PLANNING AND ZONING COMMISSION AGENDA-REGULAR MEETING

Monday, June 11, 2018

STAFF REPORT
KETCHUM PLANNING AND ZONING COMMISSION
REGULAR MEETING OF JUNE 11, 2018

STAFF REPORT
KETCHUM PLANNING AND ZONING COMMISSION
REGULAR MEETING OF JUNE 11, 2018

SECTION - FRONT SETBACK VARIANCE 1
 1/4"=1'-0"

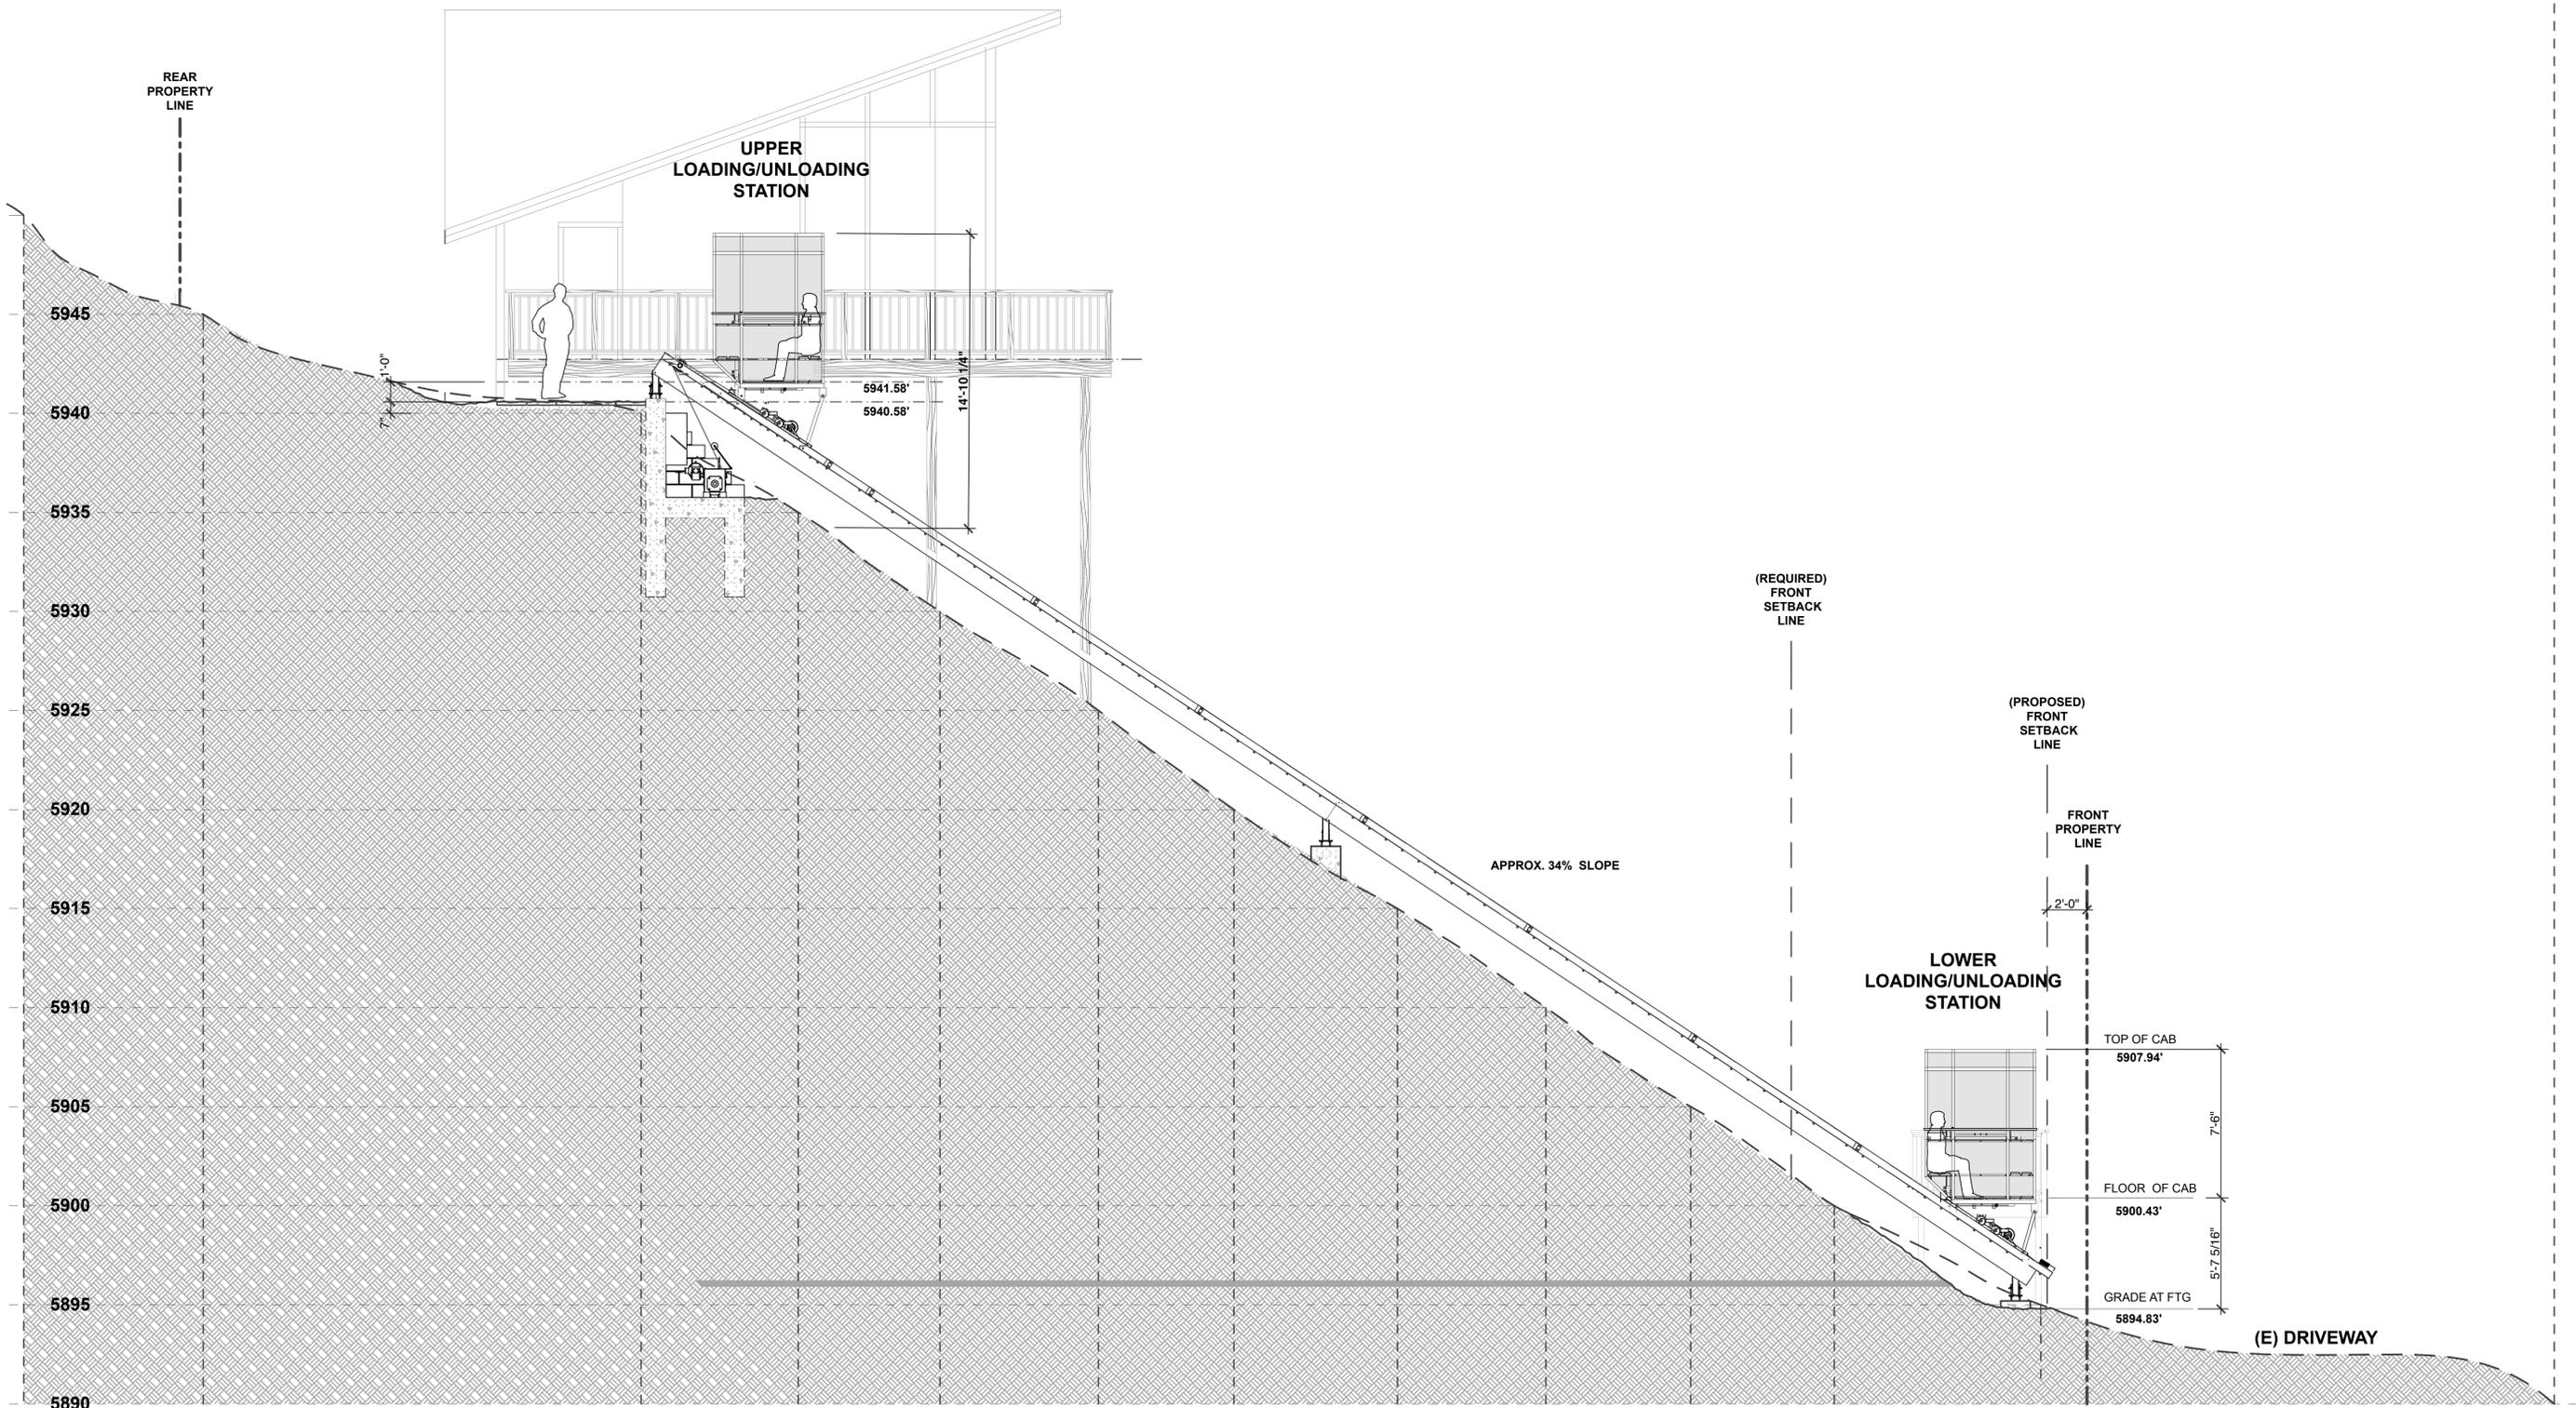
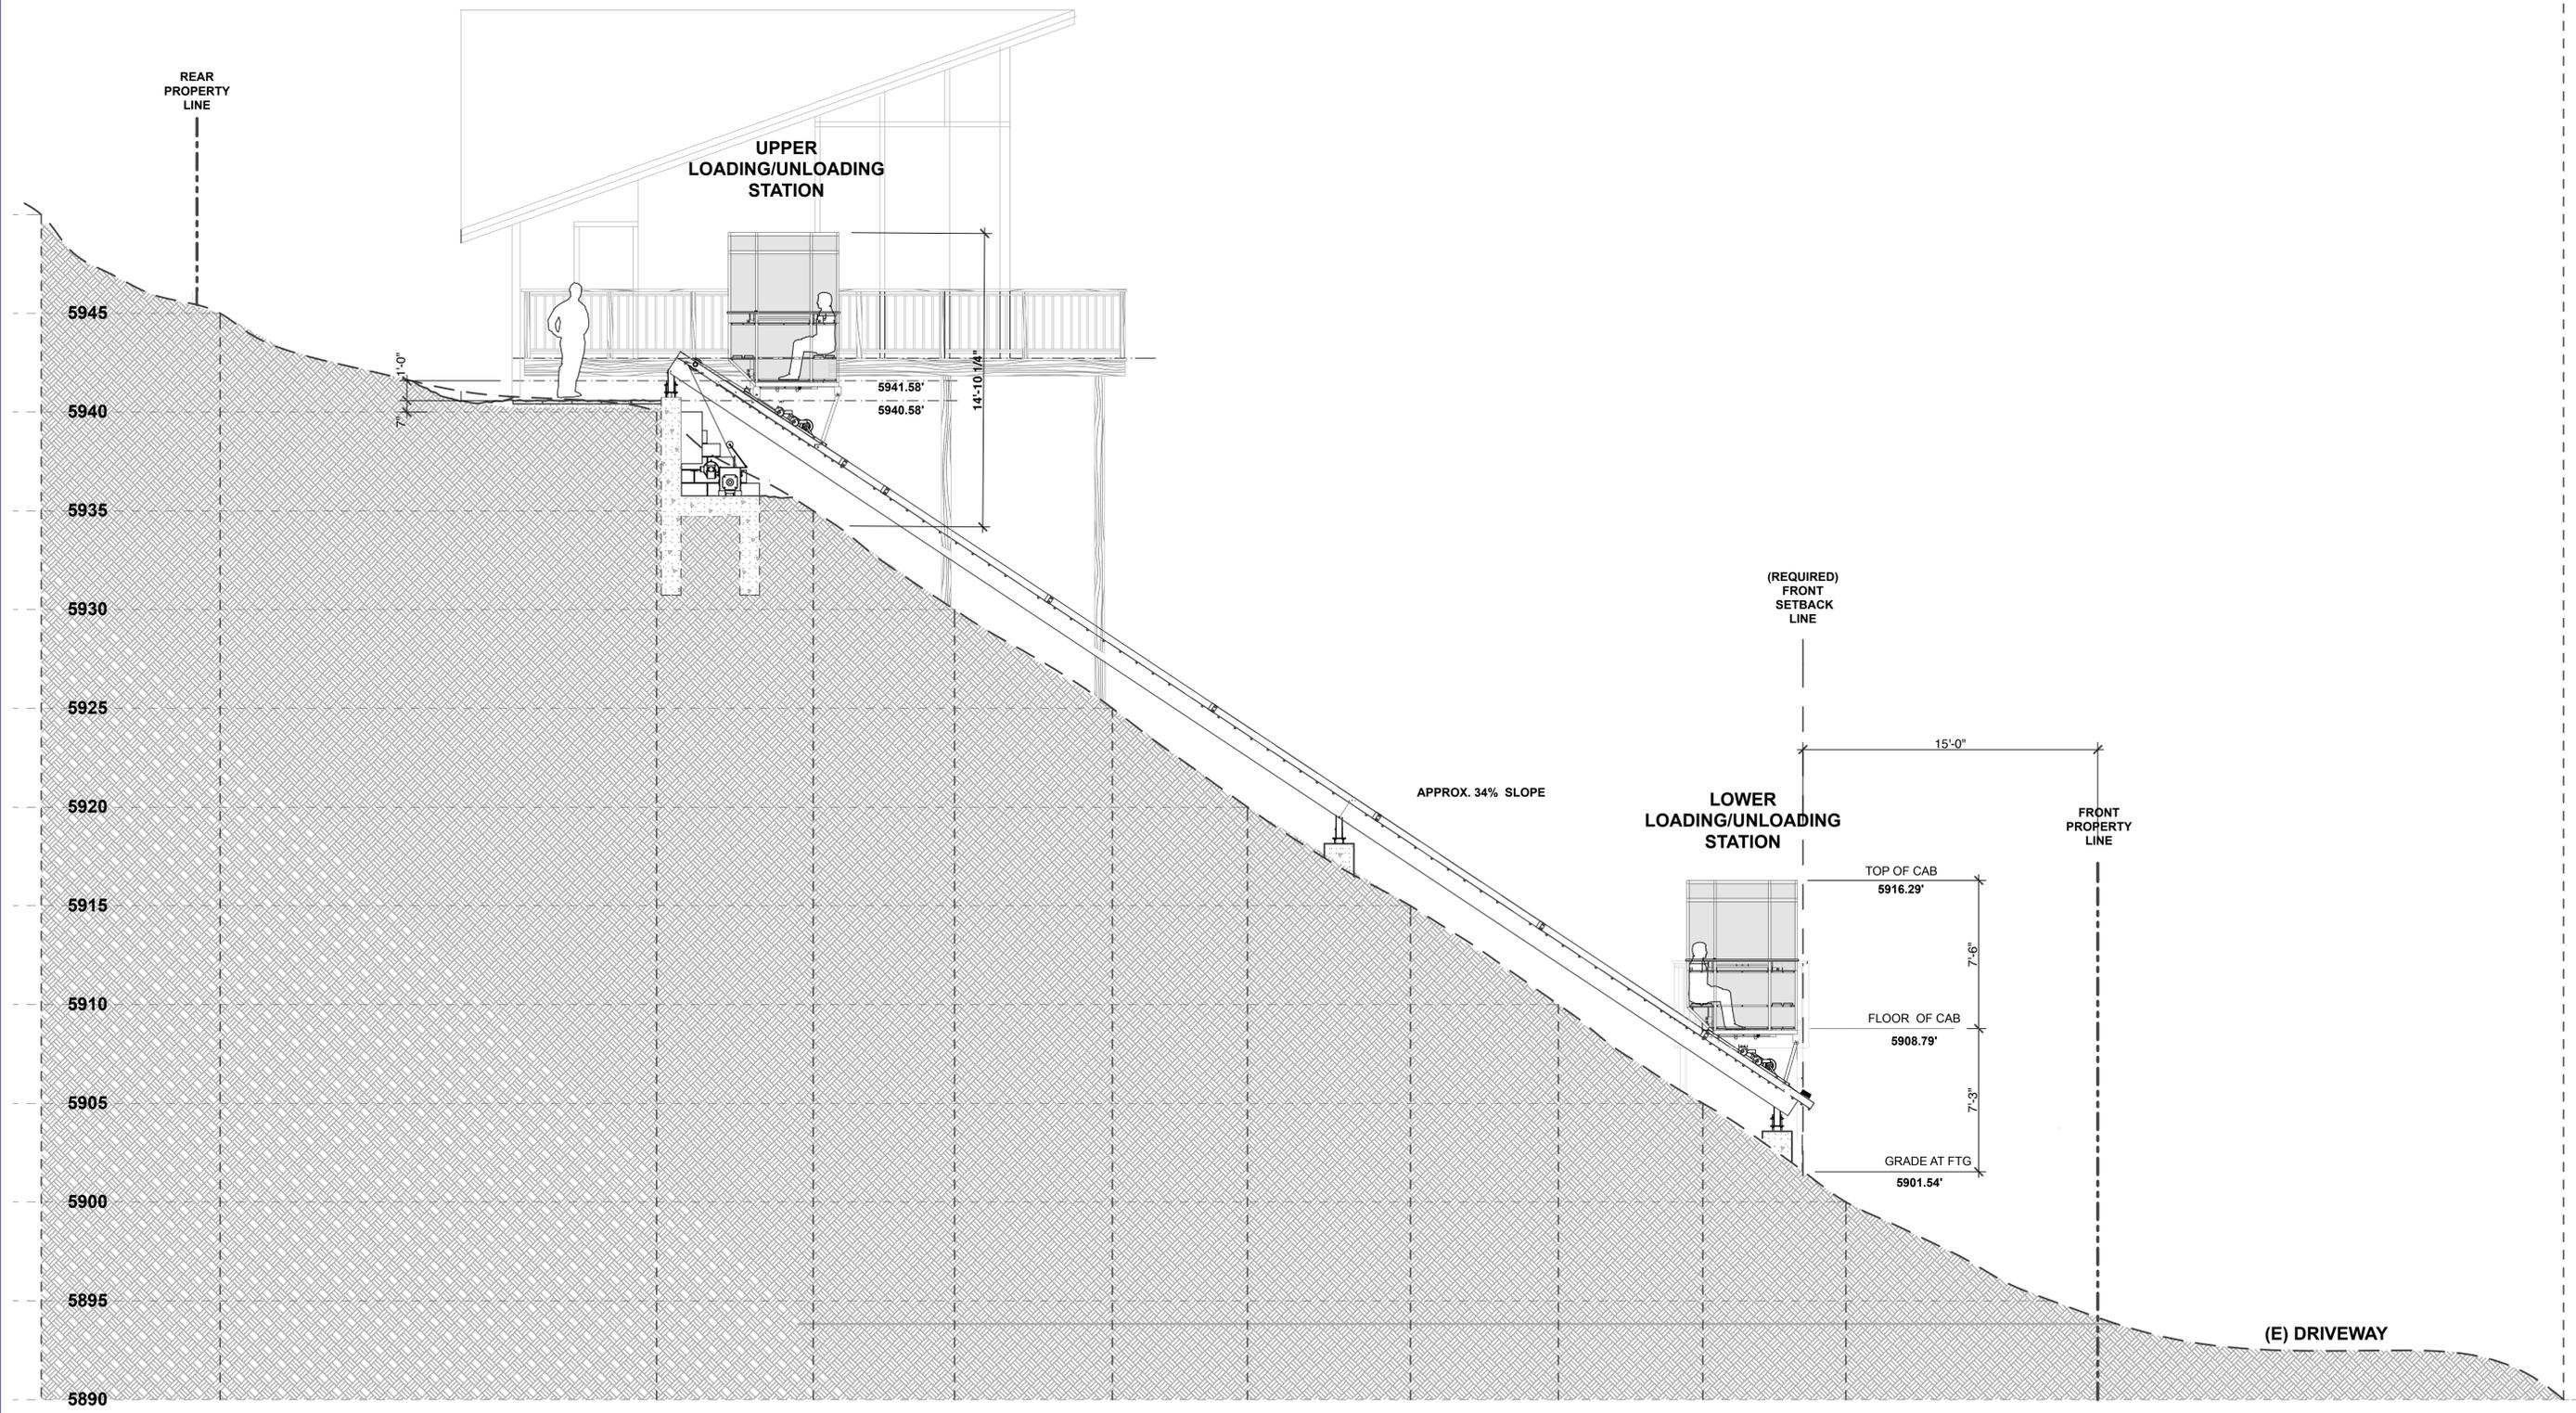
Staff has defined both the upper and lower landing areas as decks. Ketchum City Code §17.08.020 defines a deck as, “a roofless exterior floor structure attached to or supported by an adjacent structure and/or posts, piers or other independent supports.” As indicated on the Site Plan (Sheet 1.1), both the lower and upper landing platforms are noncompliant with the required front and rear setbacks in the LR Zone. The lower landing is setback 2 ft from the front lot line and the upper landing encroaches approximately 4 ft into the required 20 ft rear setback. Per Ketchum City Code §17.128.020, decks less than thirty inches in height from existing grade may be constructed to the property line. Both platforms exceed 30 inches in height above grade—the lower lift station is 5 ft in height from grade and the upper lift station is 11 ft in height from grade. In order to comply with the dimensional standards of the LR Zone, the applicant may either site the lift system within the required setbacks or decrease the height of the platforms to no more than 30 inches above grade. Lowering the proposed height of the lift system landing areas would necessitate more hillside disturbance. The applicant has also included a Site Plan on Sheet 1.2 of the submittal indicating the lower lift station setback 15 feet from the front lot line, however this design may reduce the project’s utility to the property owner and increase visibility on the hillside. Due to the topography of the lot, siting the upper lift station within the required rear setback is infeasible.

Compliance with Zoning Standards				
Compliant			Standards and Staff Comments	
Yes	No	N/A	Guideline	City Standards and Staff Comments
<input checked="" type="checkbox"/>	<input type="checkbox"/>	<input type="checkbox"/>	17.12.040	Minimum Lot Area
			<i>Staff Comment</i>	Required: 9,000 square feet minimum. Existing:: 10,355 sq ft
<input checked="" type="checkbox"/>	<input type="checkbox"/>	<input type="checkbox"/>	17.12.040	Building Coverage
			<i>Staff Comment</i>	Permitted: 35% Proposed: 13%
<input type="checkbox"/>	<input checked="" type="checkbox"/>	<input type="checkbox"/>	17.12.040	Minimum Building Setbacks
			<i>Staff Comment</i>	Minimum: Front: 15' Side: > of 1' for every 2' in building height, or 10' (17' required) Rear: 20' Proposed: The proposed platforms are noncompliant with the required setbacks in the LR Zone. The lower landing station is setback 2 ft from the front lot line. The upper landing station is setback 15'-9" from the rear lot line.
